Nutone

Supplemental Information

MODELS 2011-2012

Intercom—Radio

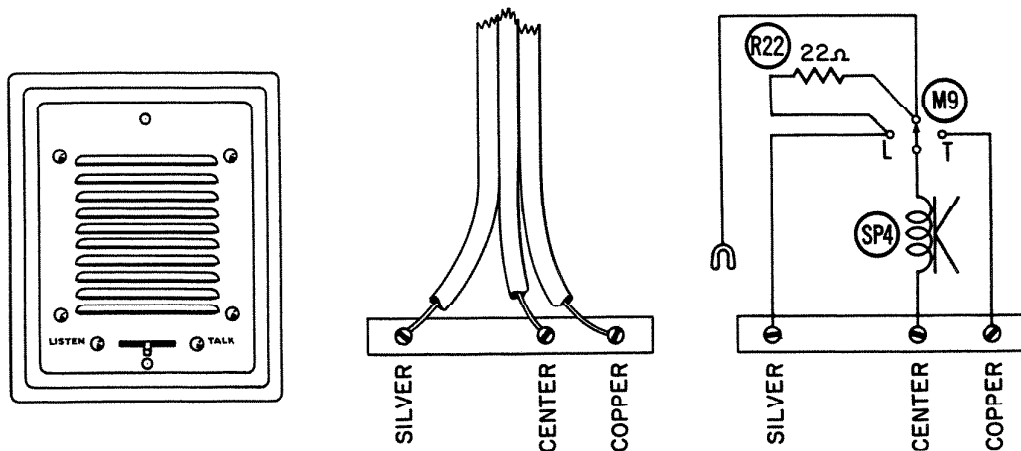
Outdoor remote change Model 2005 (effective January, 1959). Incorporated a talk-listen switch

and will be wired with 3 conductor cable, (same as the inside remotes.)

Connect the three intercom wires to the terminals on the speaker. This allows reduced volume from the speaker when the switch is in the center position. For maximum volume switch must be moved to listen position.

Remove the insulation from the lug of jumper wire and connect lug to the terminal marked "silver" along with the intercom wire. Also, connect the "center" and "copper" wires. This connection allows full volume when the switch is in the center position.
